SVE BULLETIN

QVM BULLETIN: Q-287R2

DIESEL FUEL CONDITIONING MODULE RELOCATION SERVICE KIT

All 2021 F-650 / 750 Vehicles (See Page 1) and 2016 - 2019MY F-650 / 750 (See Page 2) Equipped with Diesel Engines

2021MY+ F-650 / 750:

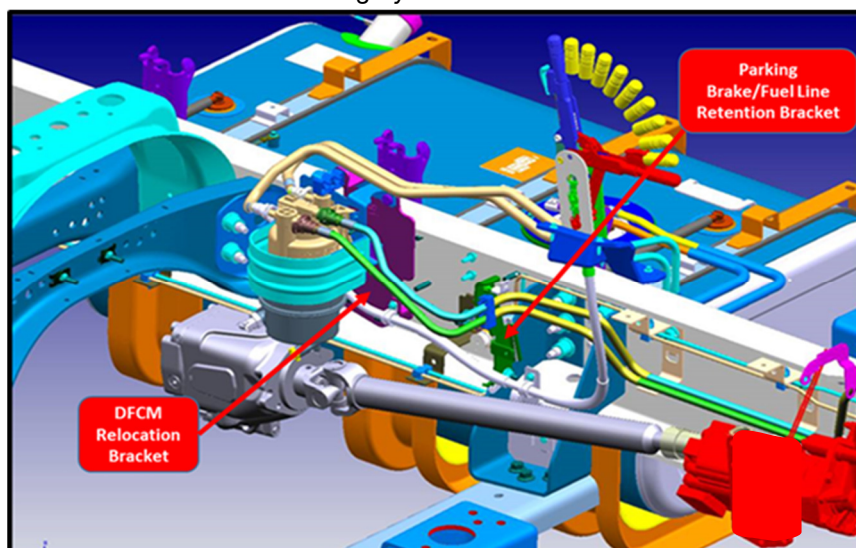
In some applications, the **Diesel Fuel Conditioning Module (DFCM)** needs to be relocated to facilitate installation of a PTO accessory to take full advantage of available engine HP and Torque.

Ford Motor Company has developed a Service Kit which relocates the **DFCM** to provide a clean PTO driveline routing.

The kit service part number for the 2021 Model Year is: **MC4Z-9S317-A**

- DFCM Relocation Bracket
- Parking Brake/Fuel Line Retention Bracket
- Replacement Fuel Supply Lines
- Additional Hardware and Installation Instructions

2016 - 2019MY F-650 / 750:

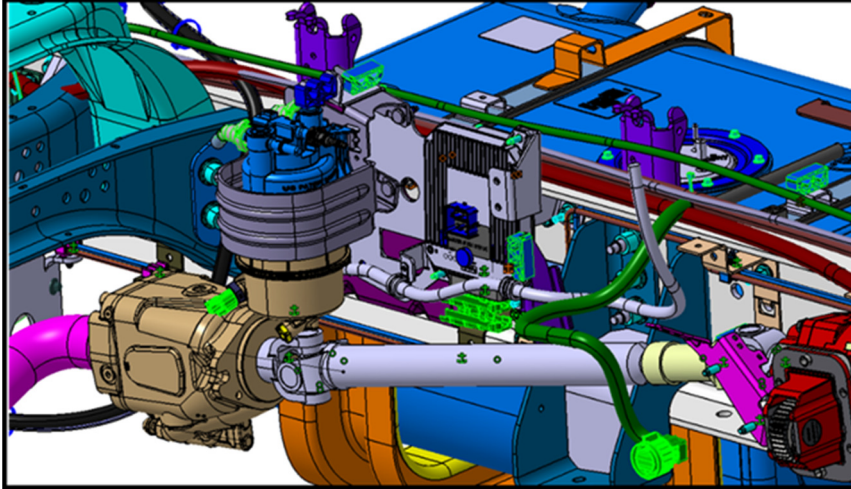
The kit service part number for the 2016 through 2019 Model Year is: **JC4Z-9S317-C**

- DFCM/TCM Relocation Bracket
- Parking Brake/Fuel Line Retention Bracket
- Replacement Fuel Supply Lines
- Additional Hardware and Installation Instructions

Service Kit JC4Z-9S317-C is available through your authorized Ford Service location.
